Impress Printing & Embroidery

5 October 2023

Observations

Lack of lateral stability

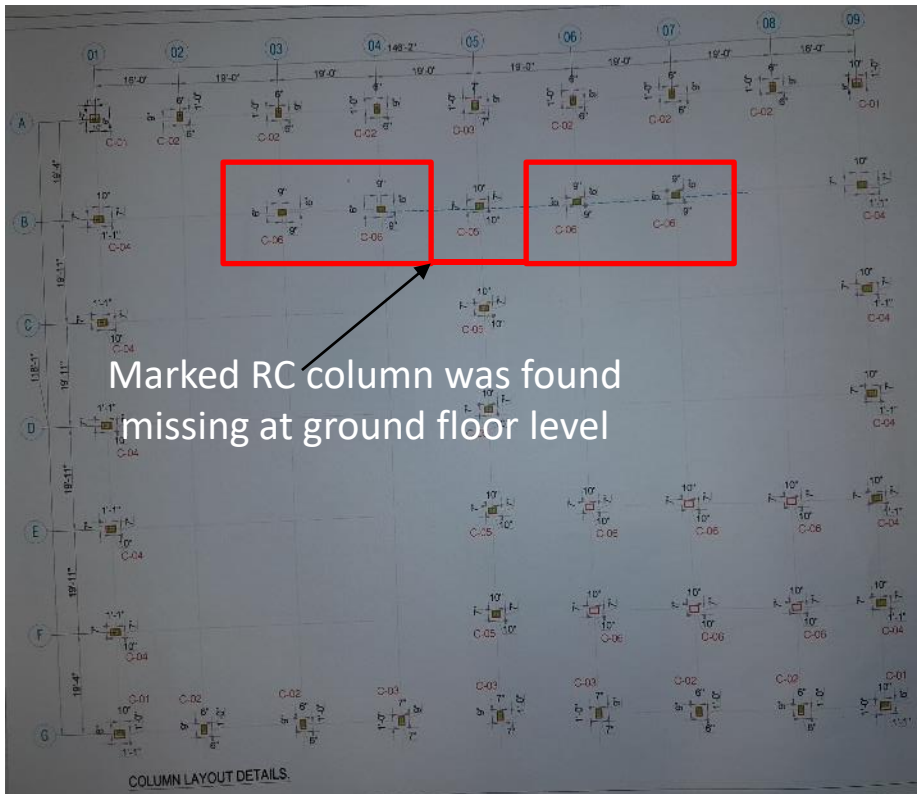
Absence of load transfer media (compression strut) along transverse direction of rafter and absence of bracing both at sidewall & roof

Lack of lateral stability system (bracing & compression strut) was observed in the structure. The building engineer is required carryout Engineering Assessment (EA) to check the lateral stability of the structure and suggest proper remedial actions accordingly. Submit the EA documents to the RSC for review.

RC Column layout

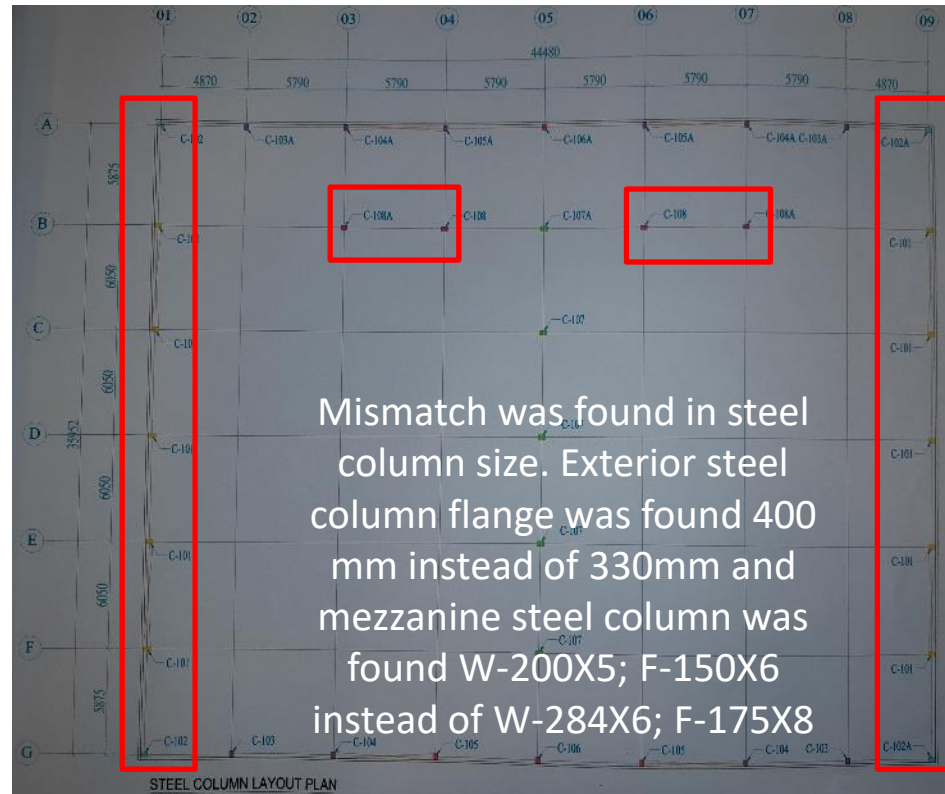
During inspection, mismatch was found between onsite condition and as-built drawing. Marked RC column was found missing at ground floor, some steel column size was found oversized and undersized, and mismatch was found in steel beam size at mezzanine floor. The building engineer is required to survey the full structure and produce accurate as-built drawings.

Distorted steel column of mezzanine

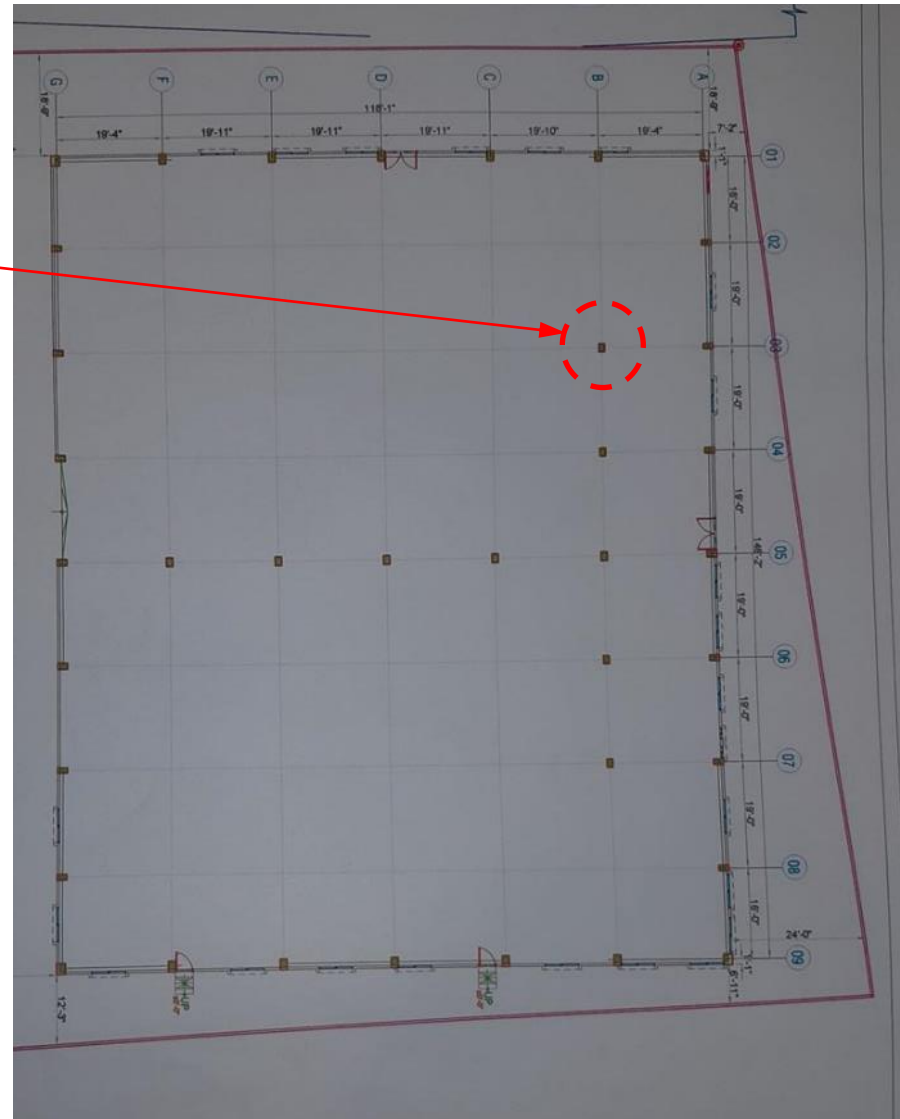
Distorted steel column

Distorted steel beam-column joint

Steel column of mezzanine floor at south-east corner is distorted. The connection between that column and steel beam also seems inadequate. The building engineer is required to investigate the reason of such distortion and take necessary action for remedial procedure.
